1988 - 1989 Corvette: Hood Rubs Air Conditioning Hose

Source: Chevrolet Dealer Service Bulletin

Bulletin No: 89-183-1B

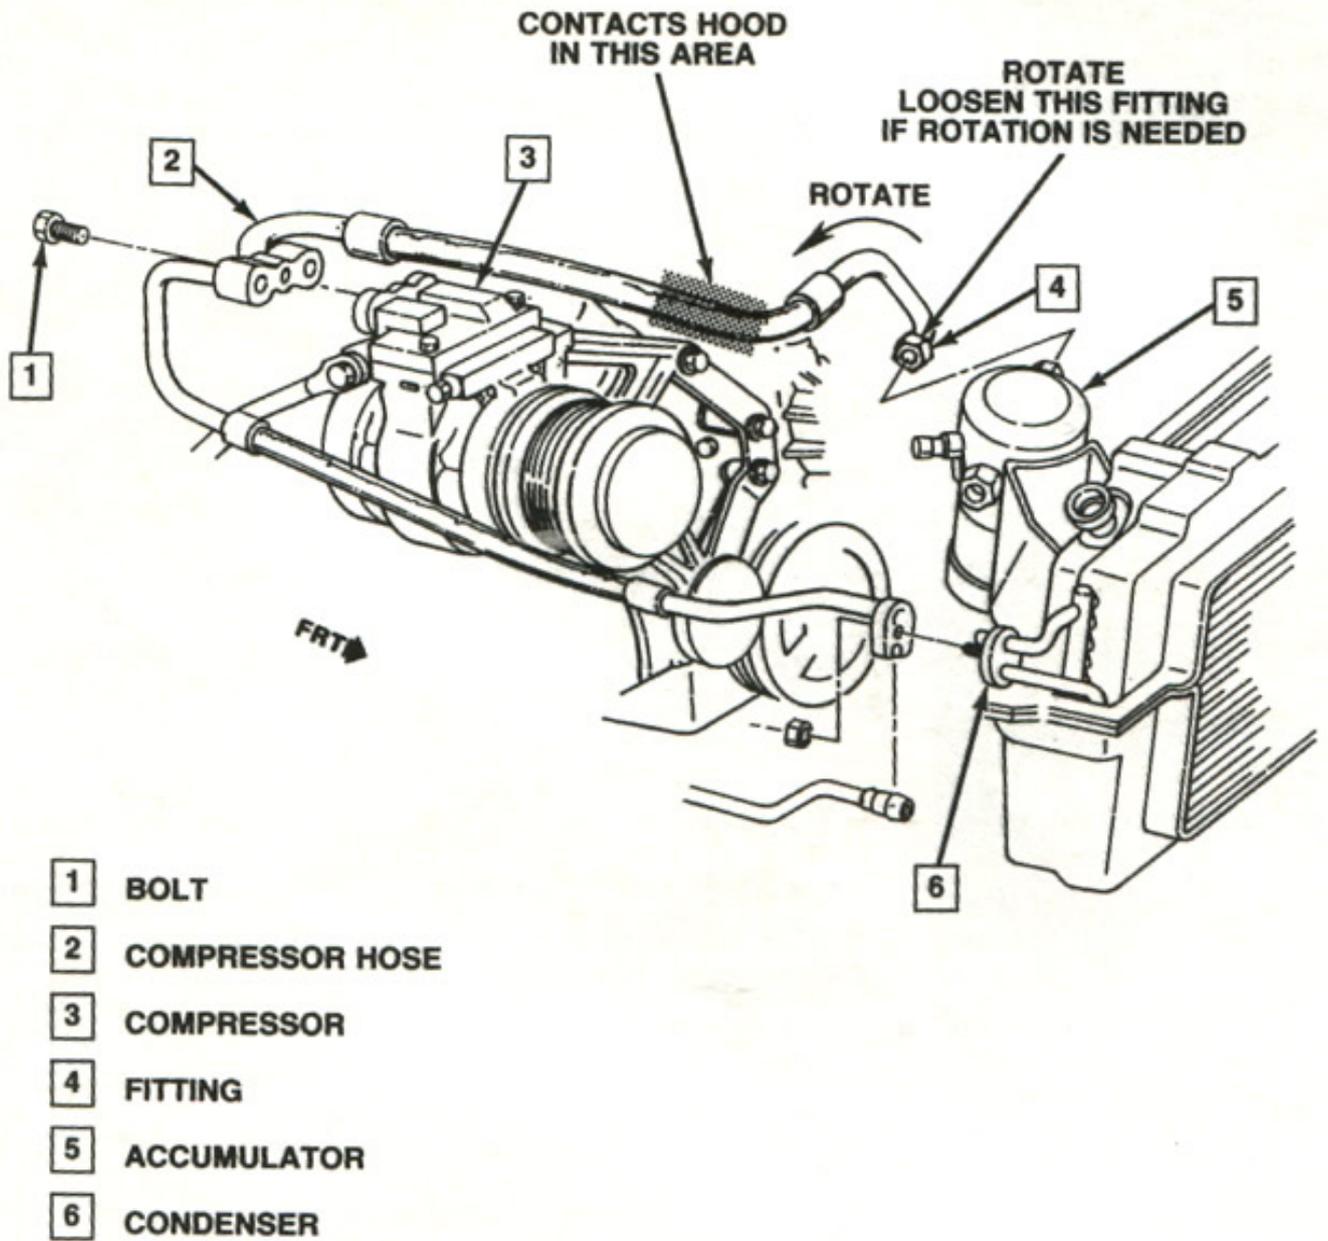
Some of the above vehicles, built prior to the breakpoint shown below, may exhibit a rub condition of the A/C hose to the underside of the hood. use the following procedure to check and address this condition. (Figure 1 shows hose disassembled for clarification only).

1. Check the area of A/C hose, as indicated in Figure 1, to see if it is contacting the hood. If there is no evidence of hose contact to hood, no further action is needed.
2. If the hose is contacting the hood but has not rubbed through the outer coating of hose, loosen the nut (item #4) on the accumulator (Item #5) and rotate the hose, in the direction indicated in Figure 1, to obtain clearance to the hood.
3. if the hose is rubbed through the outer coating, replace the hose assembly with one of the following service part numbers.

Part Number

10135634

10135635
